Churches of Chiloé (Chile) No 971bis

Churches of Chiloé

2 Issues raised

Map showing the proposed buffer zone of the component 010, San Carlos Borromeo de Chonchi church

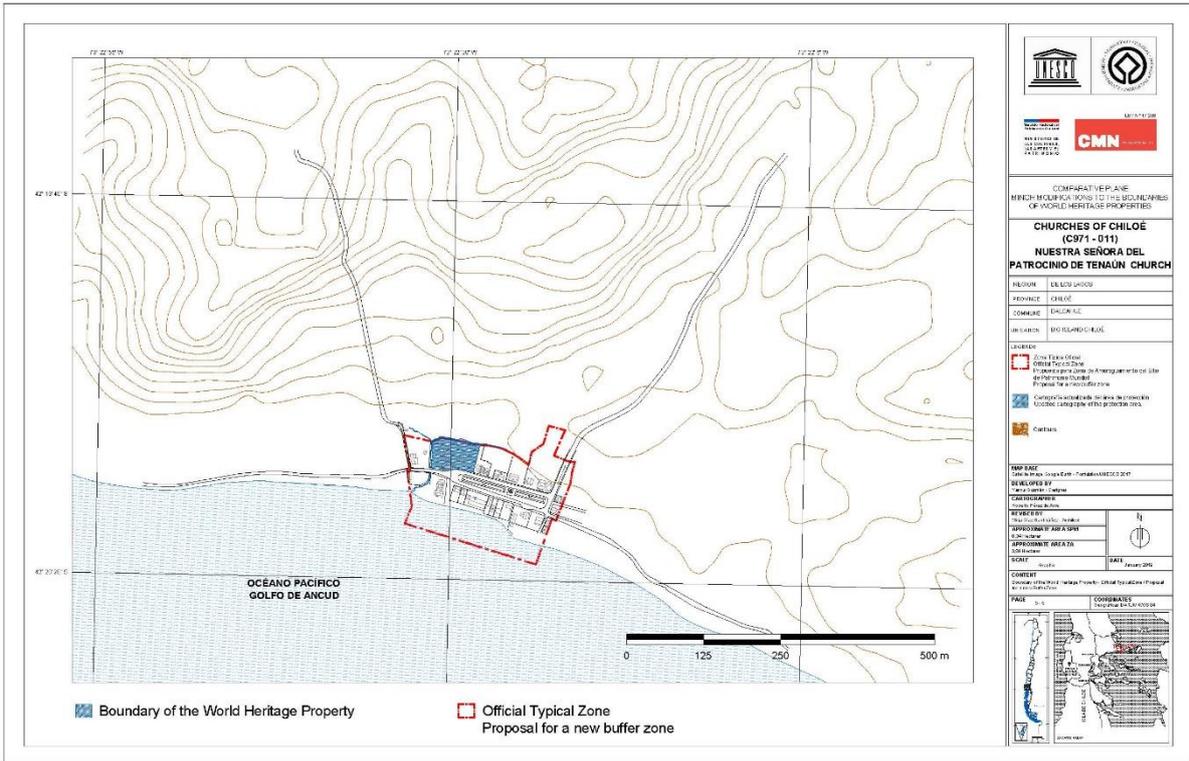
In Chonchi, the proposed buffer zone includes a large section of Centenario Street, which represents a particular typology of the Chilote urbanism and where, in addition to the church, there are high-value constructions for the area. It also includes an area of 80 meters, from the sea to the coastal edge, incorporating the dock of the town. It is recommendable, however, that the buffer zone includes the area behind the church, where the

topography and vegetation are important as part of the church's setting, as proposed in the Preliminary Protection Area.

ICOMOS recommends that the examination of the proposed minor modification to the boundary of the buffer zone of the component Chonchi of the serial property Churches of Chiloé, Chile, be **referred back** to the State Party in order to allow it to:

- Extend the proposed buffer zone to include the area behind the church, where the topography and vegetation are important as part of the church's setting;

Map showing the proposed buffer zone of the component 011, Nuestra Señora del Patrocinio de Tenaún church

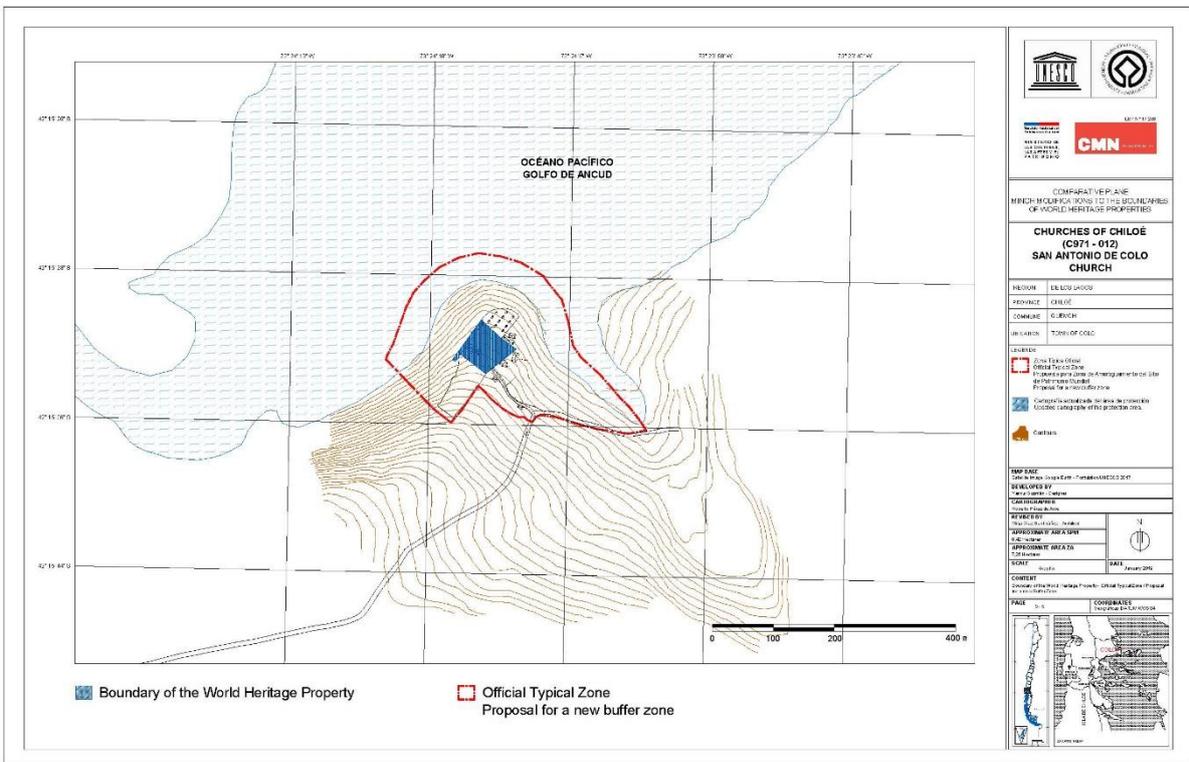
In Tenaún, the proposed buffer zone includes a section of the main road of the town, with its median strip and its linearly arranged constructions running parallel to the coastal edge; it also includes a sea area 80 meters deep from the highest tide line. It is recommended, however, that the buffer zone includes part of the surrounding landscape, with its topography and vegetation, as proposed in the Preliminary Protection Area.

ICOMOS recommends that the examination of the proposed minor modification to the boundary of the buffer zone of the component Tenaún of the serial property Churches of Chiloé, Chile, be **referred back** to the State Party in order to allow it to:

- Extend the proposed buffer zone to include a larger part of the surrounding landscape, with its topography and vegetation;

Map showing the proposed buffer zone of the component 013, San Juan Bautista de San Juan church

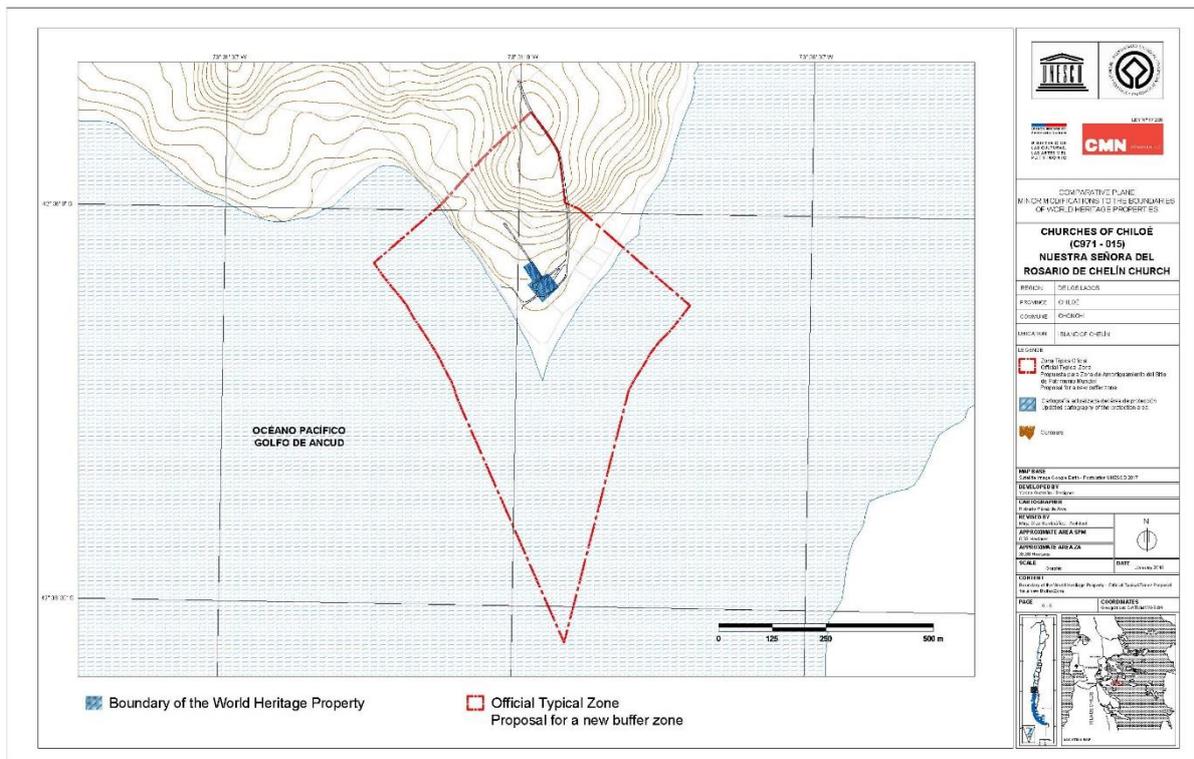
In the case of San Juan, the proposed buffer zone includes the esplanade of the church, its associated cemetery and a large sector with housing; it also includes the San Juan estuary area that faces the church and the northeast side of the most immediate hill, in order to protect the views towards the church and the environmental value of the place. It is recommended, however, that the buffer zone includes a larger area of the surrounding landscape, with its topography and vegetation, as proposed in the Preliminary Protection Area.

ICOMOS recommends that the examination of the proposed minor modification to the boundary of the buffer zone of the component San Juan of the serial property Churches of Chiloé, Chile, be **referred back** to the State Party in order to allow it to:

- Extend the proposed buffer zone to include a larger area of the surrounding landscape, with its topography and vegetation, as proposed in the Preliminary Protection Area;
